**MONTGOMERY COUNTY HISTORIC PRESERVATION COMMISSION**  
**STAFF REPORT**

<b>Address:</b>	16 West Irving Street, Chevy Chase	<b>Meeting Date:</b>	9/4/2024
<b>Resource:</b>	Contributing Resource <b>Chevy Chase Village Historic District</b>	<b>Report Date:</b>	8/28/2024
<b>Applicant:</b>	Marea Grant	<b>Public Notice:</b>	8/21/2024
<b>Review:</b>	Historic Area Work Permit	<b>Tax Credit:</b>	No
<b>Case Number:</b>	1082034	<b>Staff:</b>	Laura DiPasquale
<b>Proposal:</b>	Window replacement

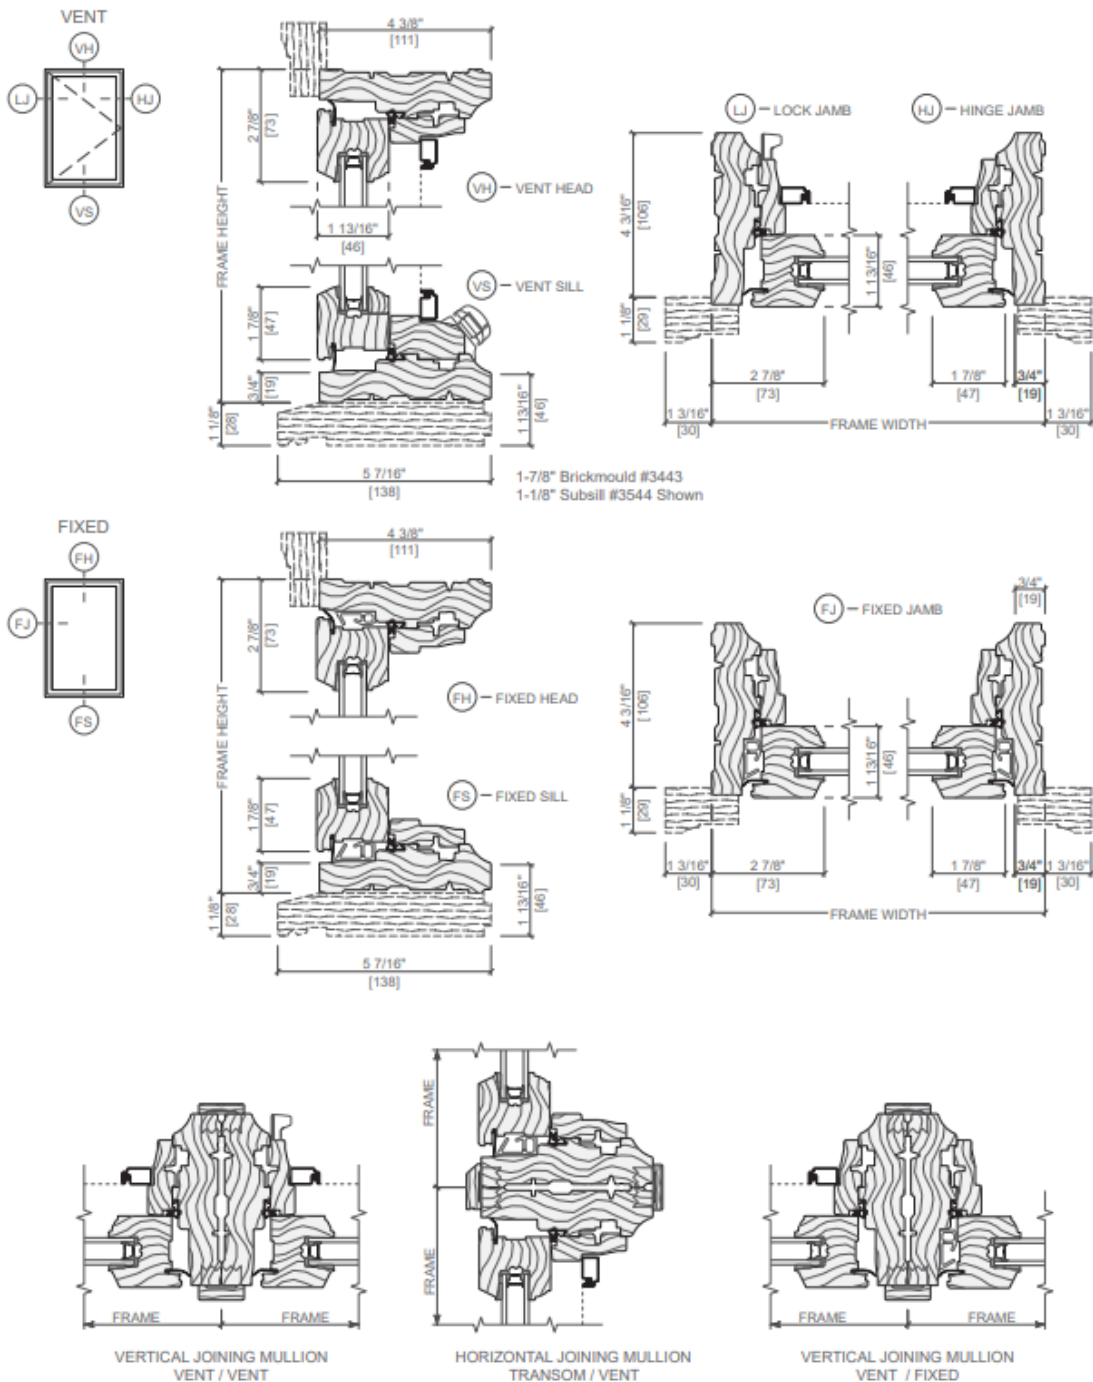
Staff finds that the windows proposed for replacement are located on the side towards the rear of the property and at the rear of the property, with limited to no visibility from the public right-of-way, respectively. The replacement windows on the side elevation should therefore be subject to moderate scrutiny and the rear windows to lenient scrutiny as detailed in the *Guidelines*.<sup>1</sup> Staff further finds that the proposed windows are wood and have traditional profiles and simulated-divided-lights with interior and exterior muntins and a spacer bar, mimicking the appearance of the original divided-light casement windows. Staff finds that while there may be slight differences in the dimensions and proportions of the proposed windows to the existing windows, the proposed differences will be nominal and not readily visible from the public right-of-way. As such, staff finds that the proposal will retain the historic character of the property, satisfying *Standard 2*, will not substantially alter the exterior features of the historic resource, and are compatible with the *Guidelines* and 24A-8(b)(1) and (2). Staff notes that the application materials indicate that some of the proposed windows will be pocket installs while others will involve full-frame replacement, but the application does not provide shop drawings showing the proposed installation method. Staff recommends that the applicants submit shop drawings detailing how the new frames will be installed for the north and west windows. The shop drawings should include the windows

in elevation, section, and plan, and depict the existing exterior trim and/or show any new exterior trim, which should match the existing. The Pella cut sheets shown in Figure 9 could be adapted to show the existing or proposed exterior trim.

1. The applicant must submit shop drawings for the north and west window, showing the installation method of the windows in elevation, section and plan. The drawings should depict how the new units will be installed within the existing exterior trim and/or show any new exterior trim, which should match the existing.
